P-12311

10426

JINDAL ALUMINIUM LTD.
BANGALORE-560073 (INDIA)

PARTY'S NAME	BANGALORE MARKET (ROLLING MILL DIVISION)
PARTY'S DRAWING No.	AS PER SPECIFICATION
ALLOY & TEMPER	19700
DESCRIPTION	FLAT BAR

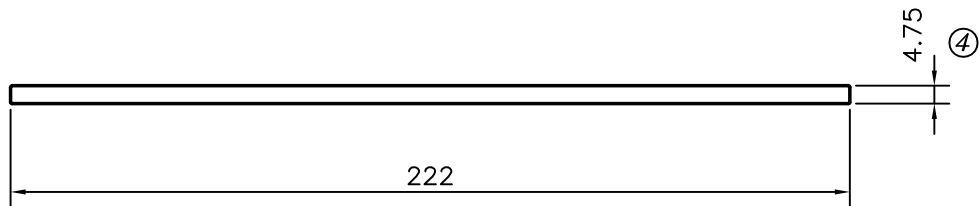
- ☞ TOLERANCE ADDED ON THICKNESS.

- ☞ THICKNESS CHANGED FROM 3.8 TO 5.9 mm.
- ☞ WEIGHT ALSO CHANGED FROM 2.277 Kg/M. TO 3.536 Kg/M.

- ☞ THICKNESS CHANGED FROM 5.9 TO 4.75 mm.
- ☞ WEIGHT ALSO CHANGED FROM 3.536 Kg/M. TO 2.847 Kg/M.
